Docket Nos. 50-390/391

FACILITY: Watts Bar Nuclear Plant, Units 1 and 2

SUBJECT: SUMMARY OF MEETING TO DISCUSS LIQUEFACTION OF THE SOILS
BENEATH THE ERCW PIPELINE

Enclosure 3

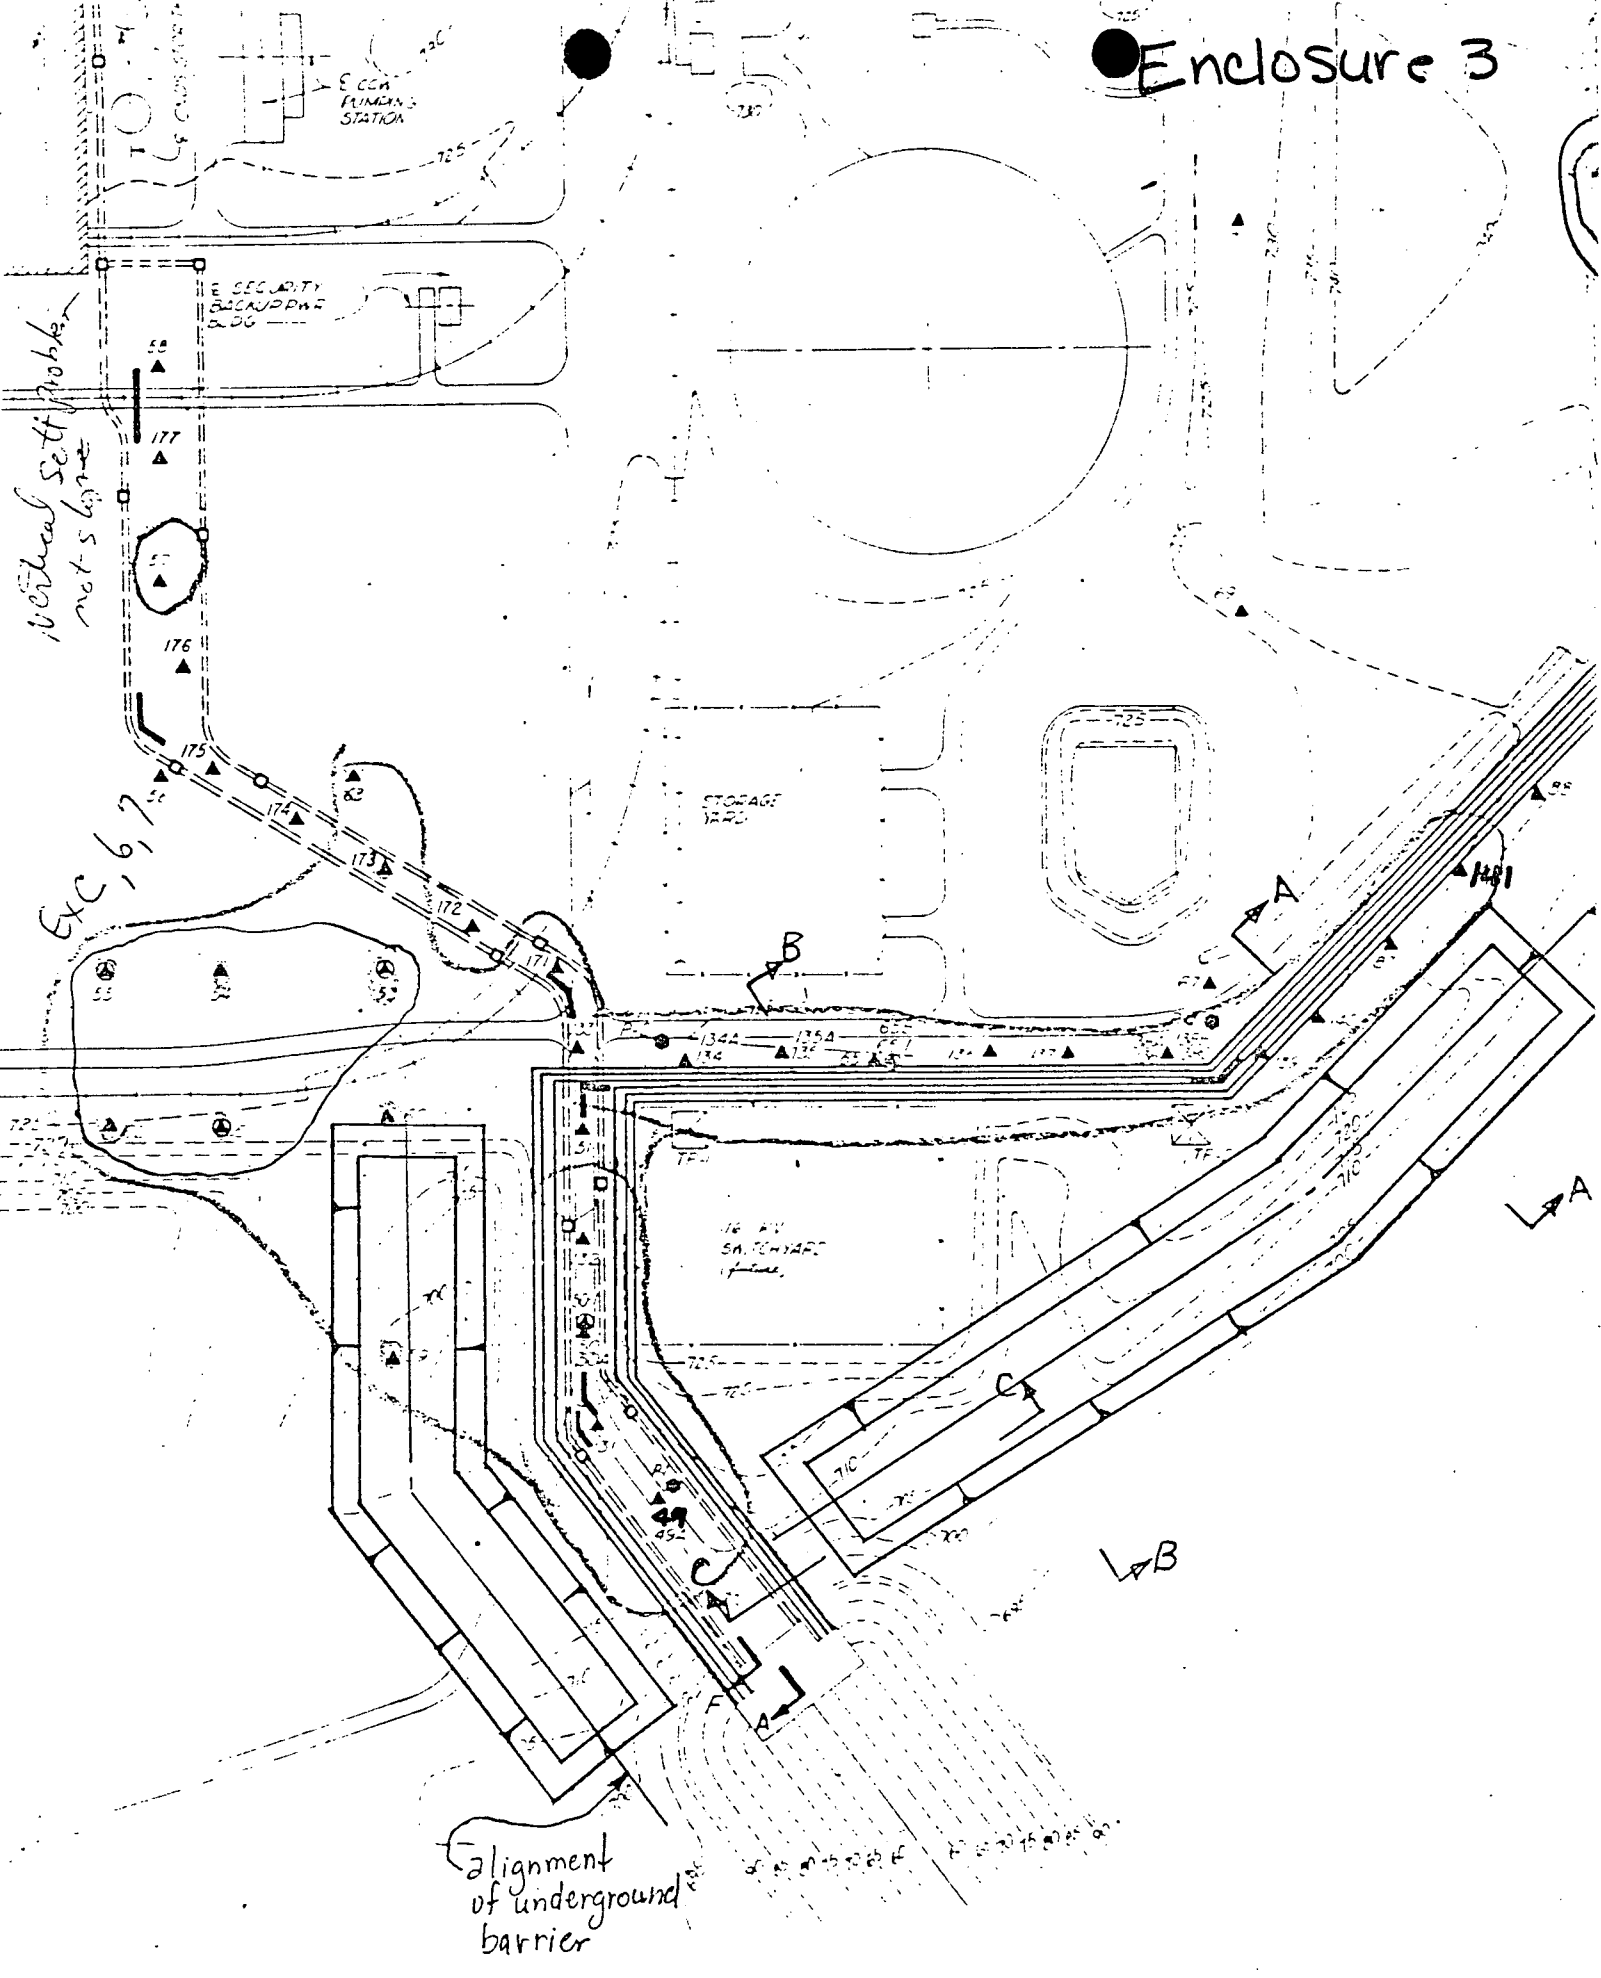
TVA proposed to construct underground barriers along the ERCW pipelines on the side of the sloping ground. The proposed alignment and cross-section of the barriers are shown in Enclosures 3 and 4. The purpose of the barriers is to contain the soils in case of any liquefaction in this area. TVA stated that they would design the barriers to withstand 0.4g maximum ground acceleration. The present design of the barriers show that these would be about 100 feet wide at the base and about 25 feet deep from the surface to the underlying shale deposit. The distance of the barriers from the ERCW pipelines would vary from 50 feet to 500 feet. Densely compacted barriers would be formed by compacting the material excavated from the location of the barriers. The compaction criterion would be 95% standard Proctor density. TVA proposes to fill the depression in the area between the ground surface at the location of the pipelines and the top of the barriers.

TVA stressed the urgency of coming to a resolution on this liquefaction issue so that remedial work may be complete by fuel load (01/03/84). The meeting closed with the NRC indicating that in a week TVA would receive a peak acceleration, or "g" value, and an indication as to the adequacy of their remedial fix.
